Meridian Firs Apartments

Deck Repair

City of Puyallup
Development & Permitting Services
ISSUED PERMIT

PRDK20241965

2 DECK EDGE
SCALE: 3" = 1'-0"

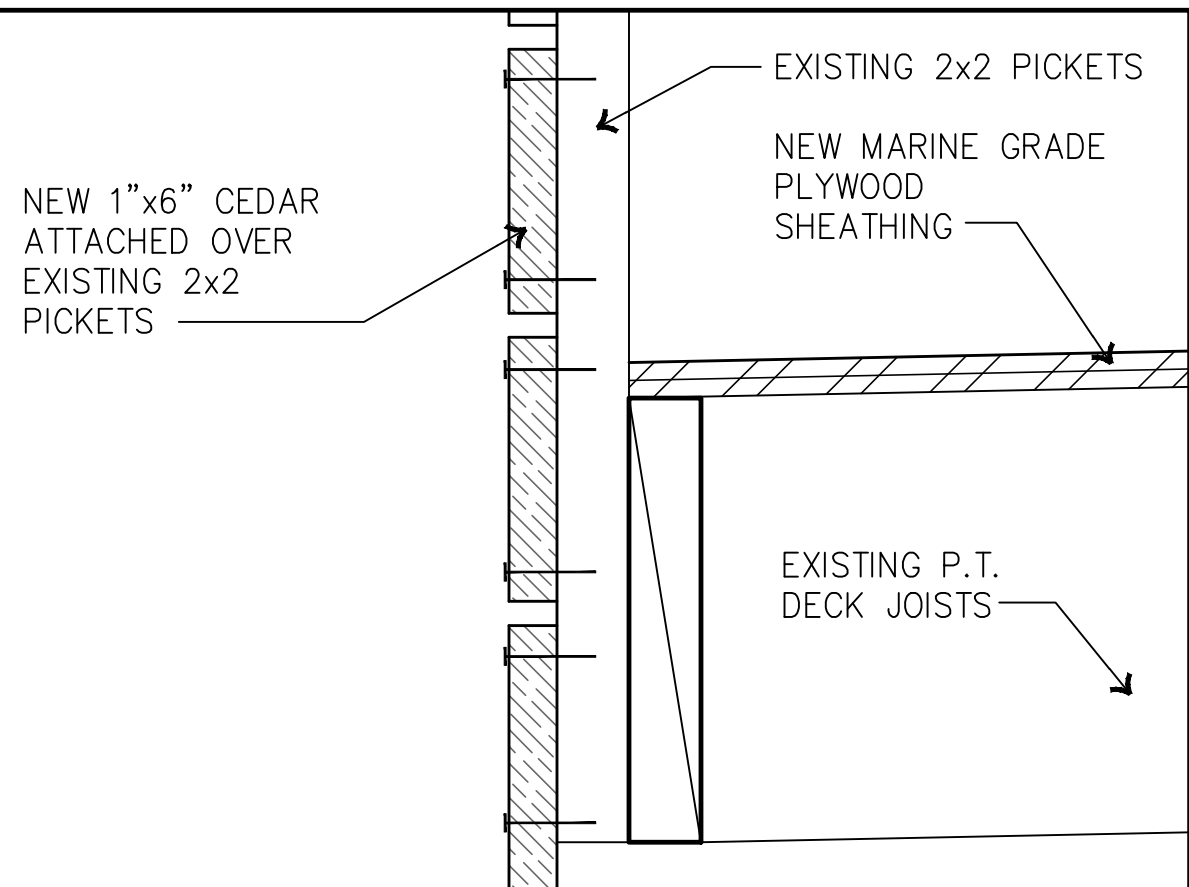
Add a notation on either Sheet A1.0 or A1.1 that contractor shall verify the integrity of balusters prior to the installation of the 1x6 cedar. Establish the parameters of the balusters replacement to include type, grade and nailing pattern.

(Construction Plans, Sheet A1.1)

Deck joists appear to be sloped to drain off of the cantilevered side of each deck based upon details 1 and 2. Detail 2 shows the installation of the 1x6 cedar board over the existing 2x2 balusters. detail or notate how the 1x6 cedar will be installed to prevent drainage and water accumulation on the deck surface.

(Construction Plans, Sheet A1.1)

Updated all details and notes as needed to reflect the requested information.

1a COLUMN TO FOOTING
SCALE: 1 1/2" = 1'-0"

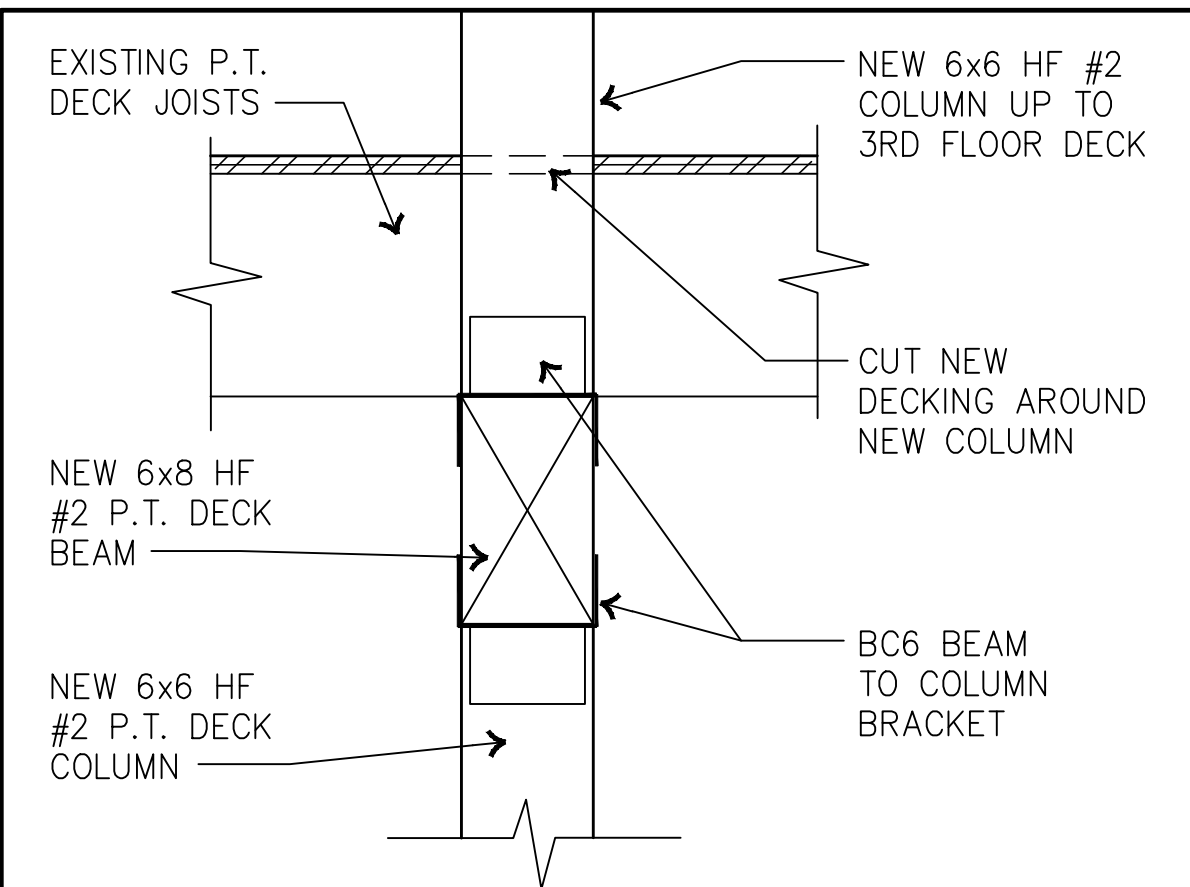
Detail the connection between the existing and proposed slab.

(Construction Plans, Sheet A1.1, Detail 1a)

(Construction Plans, Sheet A1.1)

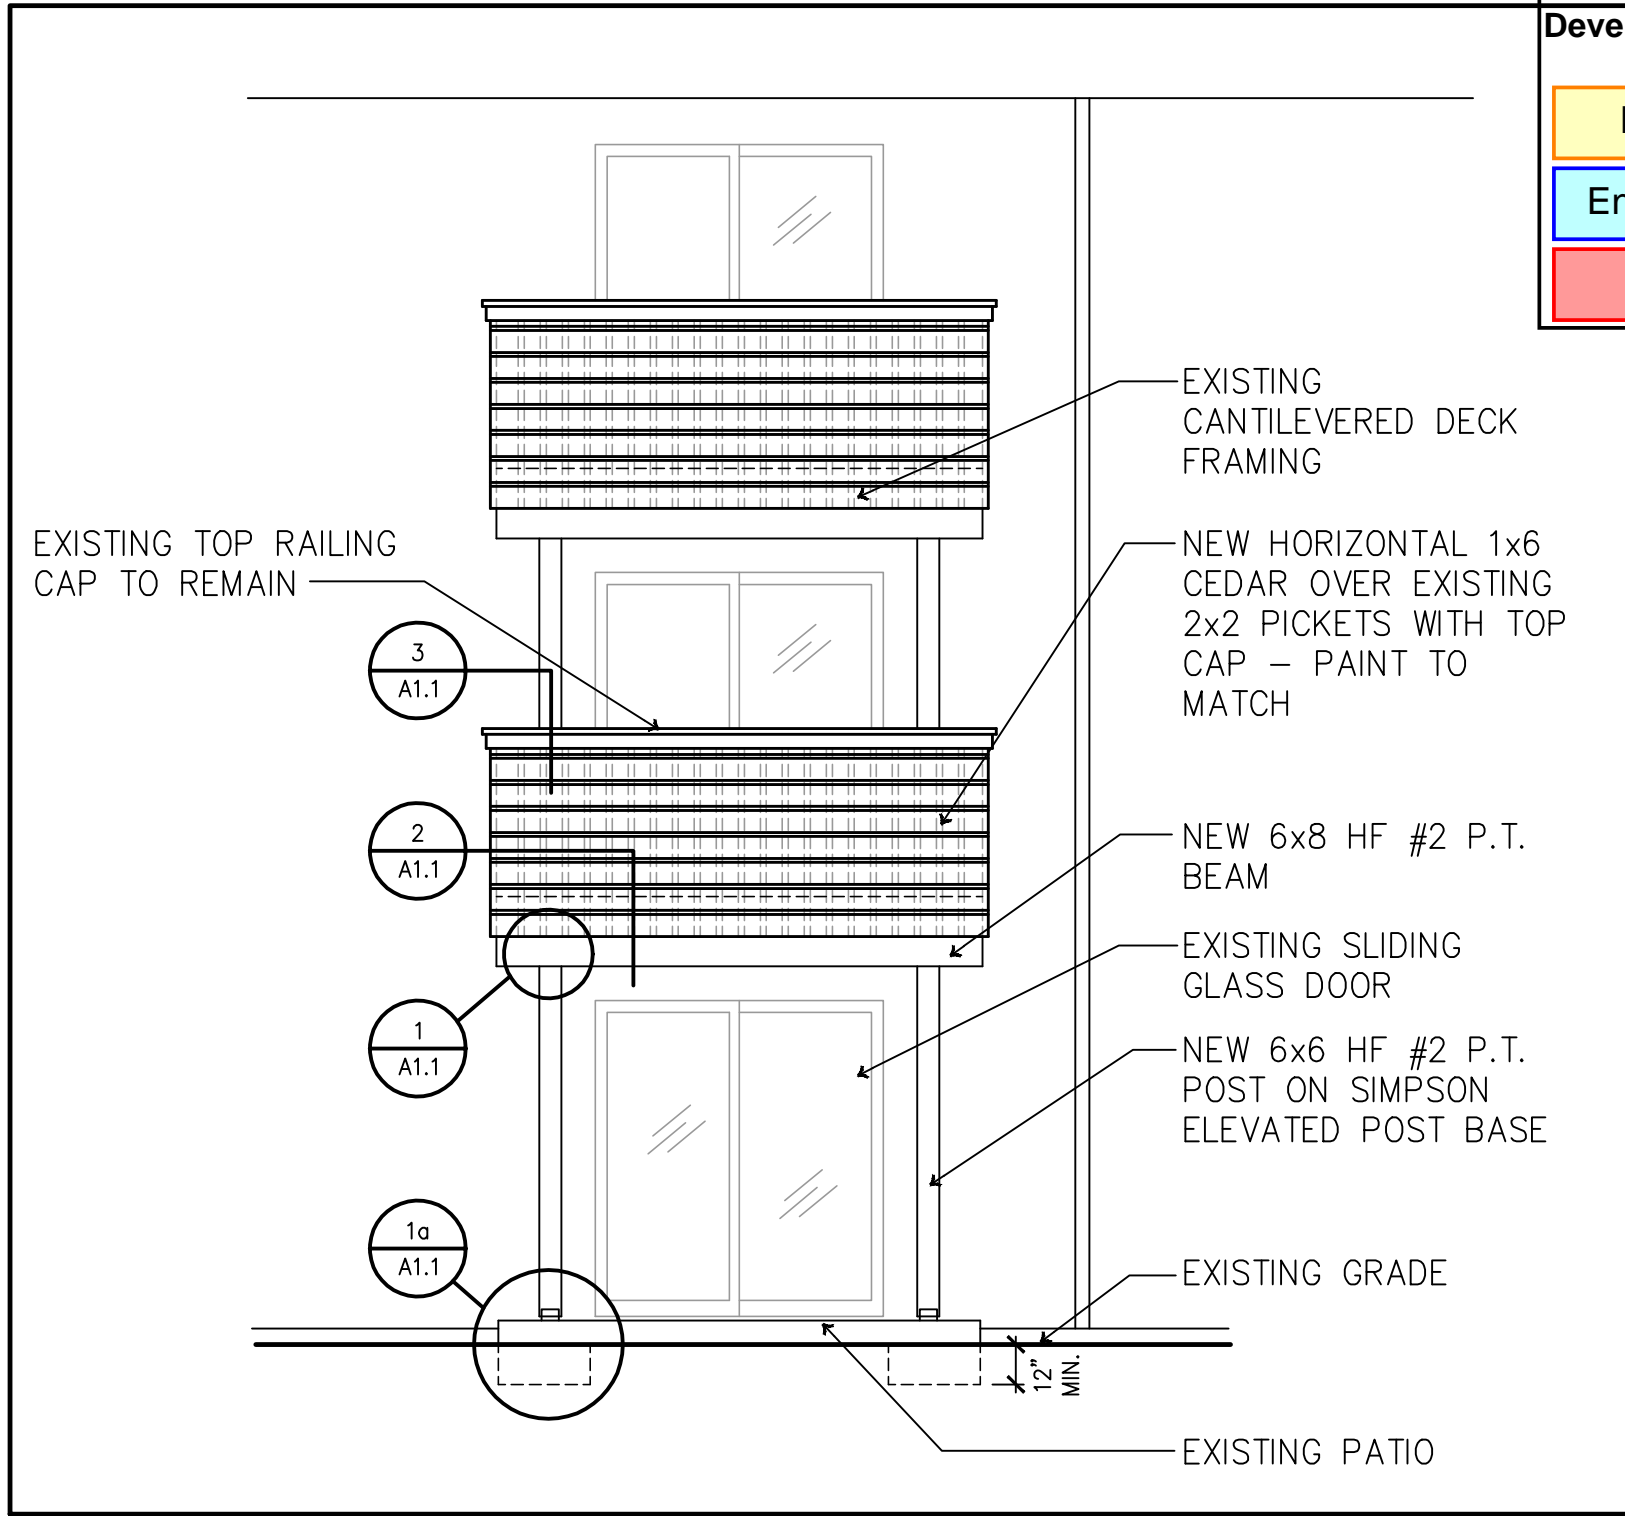
Provide specifics of the plywood that will be installed which should include plywood thickness, grade and any other specifics that will reflect that the plywood will withstand the dead and live loads of the deck. Identify the non-slip surface that will either be provided on the plywood or will be added to the plywood as part of construction, as notated on sheet A1.0, Owner/Contractor Coordination Notes.

The existing joist spacing should also be considered when selecting the plywood material that will be used. Please provide the existing joist spacing.
